Access Compliance Report

Public Rights-of-Way

(Pedestrian Signals)

Intersection ID: N/A	Main Street:	Cross Street: N/A	Location: N/A
ADA ID: 6A1889FF9263	Signal Type: One Push Button-APS	Overall Compliance: No	Severity Score: BTN 1: N/A BTN 2: N/A No BTN: N/A
Codes/Mitigation Info/Possible Solution		Field Measurements/Component Compliance

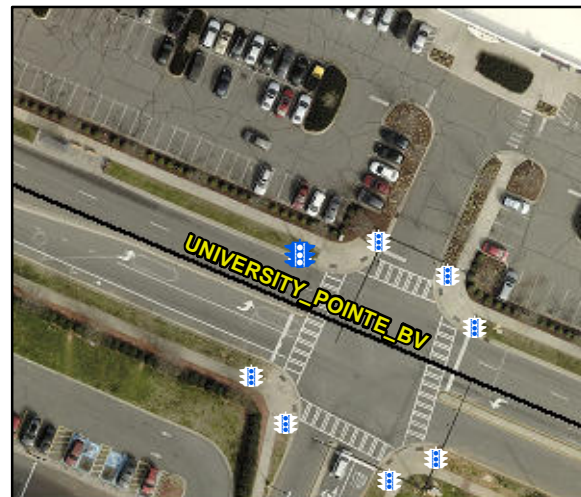
PROW/ADA: TMUTCD 4e.08, R404.2, R404.7.2, R209.1, MUTCD 4e.10

Compliance	Description	Data	Compliance	Description	Data
	Button Count	Button1	Yes	Distant to Additional Button (in)	358.0
	Additional Button Present?	Yes		Additional Button ID	FC9845C84941
N/A	Signal Buttons Required?	N/A	N/A	Additional Ped Posts Required	N/A
	How Many Ped Street Xings?	N/A		Located In An Island/Median?	N/A
N/A	B 1 Sign Present?	Yes	N/A	B 2 Sign Present?	N/A
Yes	B 1 Sign Purpose?	Yes	N/A	B 2 Sign Purpose?	N/A
Yes	B 1 Sign Lettering & Contrast?	Yes	N/A	B 2 Sign Lettering & Contrast?	N/A
Yes	B 1 Parallel To XWalk?	Yes	N/A	B 2 Parallel To XWalk?	N/A
Yes	B 1 PAR to Button?	Yes	N/A	B 2 PAR to Button?	N/A
Yes	B 1 PAR to XWalk?	Yes	N/A	B 2 PAR to XWalk?	N/A
Yes	B 1 Clear Floor Space?	Yes	N/A	B 2 Clear Floor Space?	N/A
N/A	B 1 FWD Approach?	No	N/A	B 2 FWD Approach?	N/A
N/A	B 1 FWD Approach Constrained?	N/A	N/A	B 2 FWD Approach Constrained?	N/A
N/A	B 1 FWD Approach Reach (in)	N/A	N/A	B 2 FWD Approach Reach (in)	N/A

N/A	B 1 FWD Approach Width (in)	N/A	N/A	B 2 FWD Approach Width (in)	N/A
N/A	B 1 FWD Approach Obstruction?	Yes	N/A	B 2 FWD Approach Obstruction?	N/A
N/A	B 1 FWD Approach Obstruction Dist (in)	3.0	N/A	B 2 FWD Approach ObstructionDist (in)	N/A
N/A	B 1 PARA Approach?	Yes	N/A	B 2 PARA Approach?	N/A
N/A	B 1 PARA Approach Constrained?	Yes	N/A	B 2 PARA Approach Constrained?	N/A
Yes	B 1 PARA Approach Reach (in)	10.0	N/A	B 2 PARA Approach Reach (in)	N/A
No	B 1 PARA Approach Width (in)	48.0	N/A	B 2 PARA Approach Width (in)	N/A
N/A	B 1 PARA Approach Obstruction?	Yes	N/A	B 2 PARA Approach Obstruction?	N/A
N/A	B 1 PARA Approach Obstruction Dist (in)	4.0	N/A	B 2 PARA Approach ObstructionDist (in)	N/A
Yes	B 1 Clear Floor Space Slope (%)	2.0	N/A	B 2 Clear Floor Space Slope (%)	N/A
No	B 1 Clear Floor Space XSlope (%)	3.0	N/A	B 2 Clear Floor Space XSlope (%)	N/A
N/A	B 1 PAR Slope (%)	N/A	N/A	B 2 PAR Slope (%)	N/A
Yes	B 1 Height (in)	32.0	N/A	B 2 Height (in)	N/A

N/A	B 1 Clear Xing Direction?	Yes	N/A	B 2 Clear Xing Direction?	N/A
	B 1 Crossing Direction	To S		B 2 Crossing Direction	N/A
No	B 1 DistanceTo XWalk (in)	86.0	N/A	B 2 DistanceTo XWalk (in)	N/A
No	B 1 DistanceTo Curb (in)	14.0	N/A	B 2 DistanceTo Curb (in)	N/A
Yes	B 1 Diameter (in)	2.0	N/A	B 2 Diameter (in)	N/A

Possible Solutions: Replace Signal Push Button With APS Button on New Post. Remove & Relocate Sign.
